Consumers Power Company
Palisades Plant
Docket 50-255

PROPOSED PROVISIONAL OPERATION LICENSE AND
TECHNICAL SPECIFICATION PAGE CHANGES

September 29, 1986

FIGURE 6.2-1

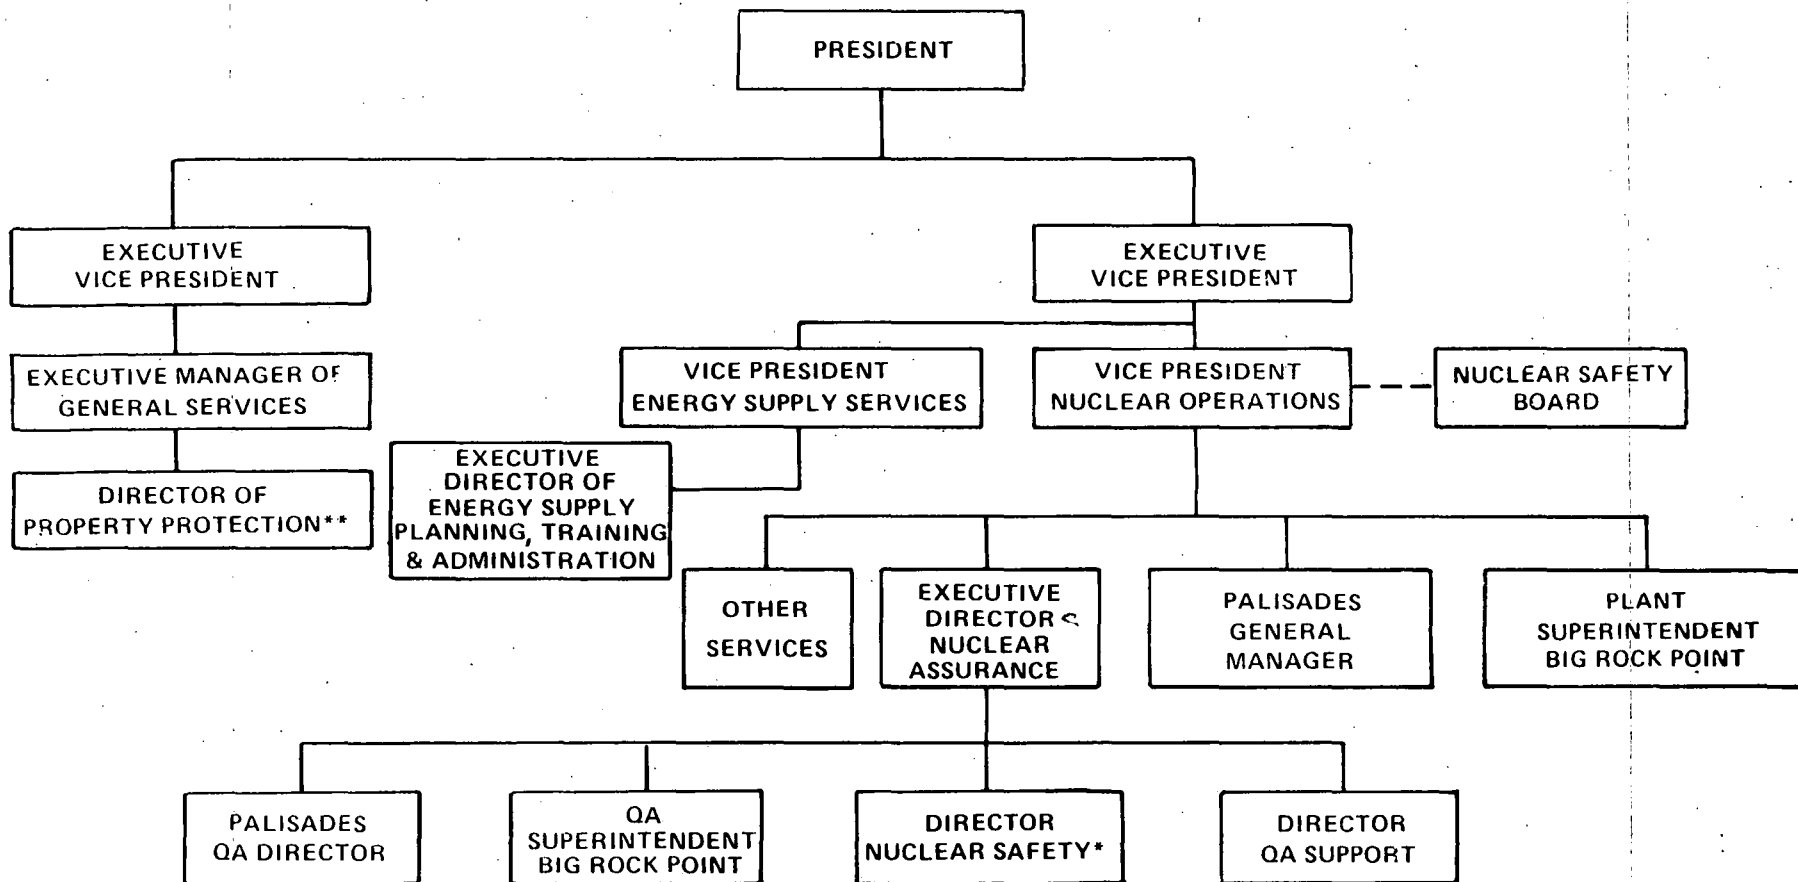
**CONSUMERS POWER COMPANY
OFFSITE ORGANIZATION**

* NSB CHAIRMAN

** RESPONSIBLE FOR OVERALL FIRE PROTECTION PROGRAM

Figure 6.2-2

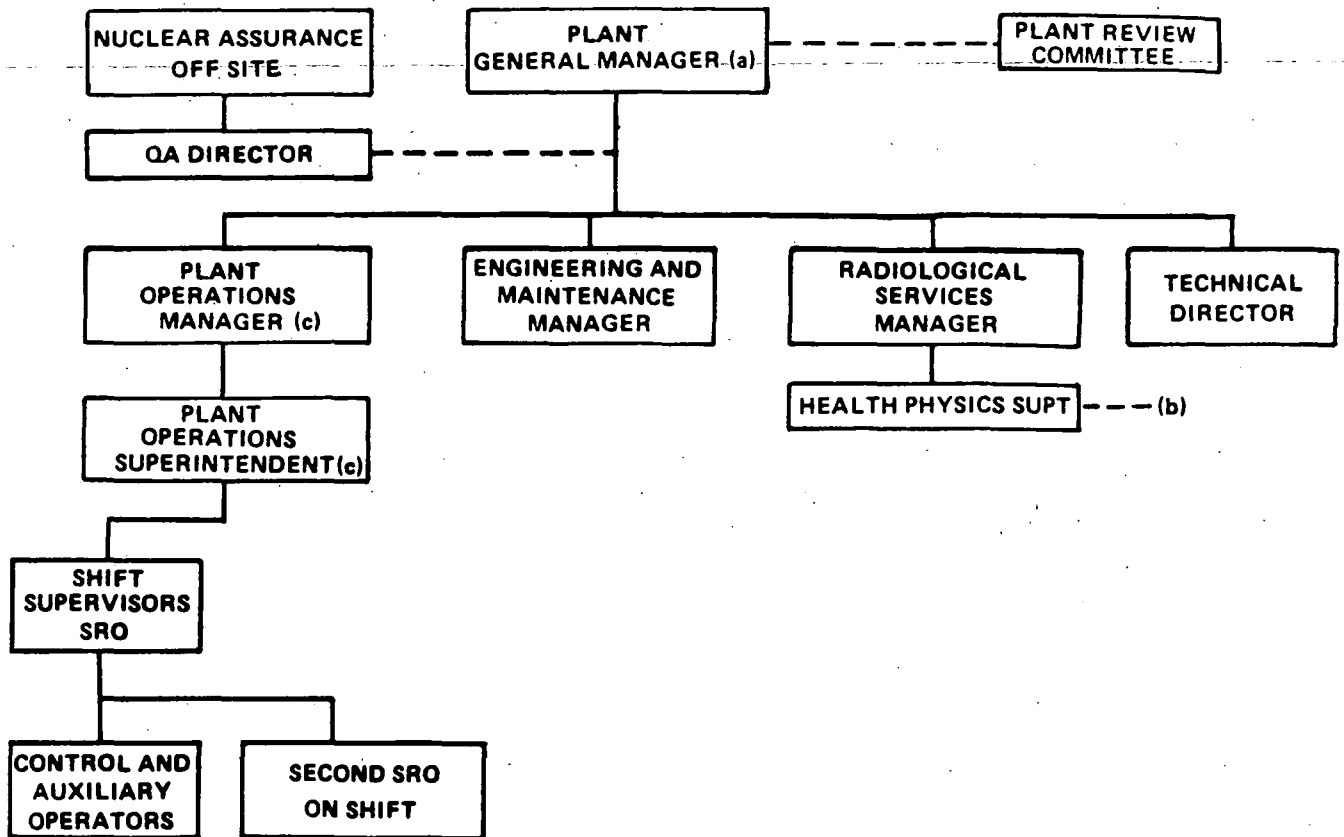
(a) Responsible for the Plant Fire Protection Program implementation.

(b) A Radiation Safety Manager (RPM as defined in Regulatory Guide 1.8) shall be designated by the Plant General Manager and shall be either the Radiological Services Manager or the Health Physics Superintendent. The Radiation Safety Manager shall have direct access to the Plant General Manager in the matters of radiation safety.

(c) Either the Plant Operations Manager or the Plant Operations Superintendent will hold a SRO License and meet the other requirements of 6.3.1 of these Technical Specifications (as applicable to Operations Manager in ANSI N18.1). The individual holding a SRO License shall be responsible for directing the activities of licensed operators.
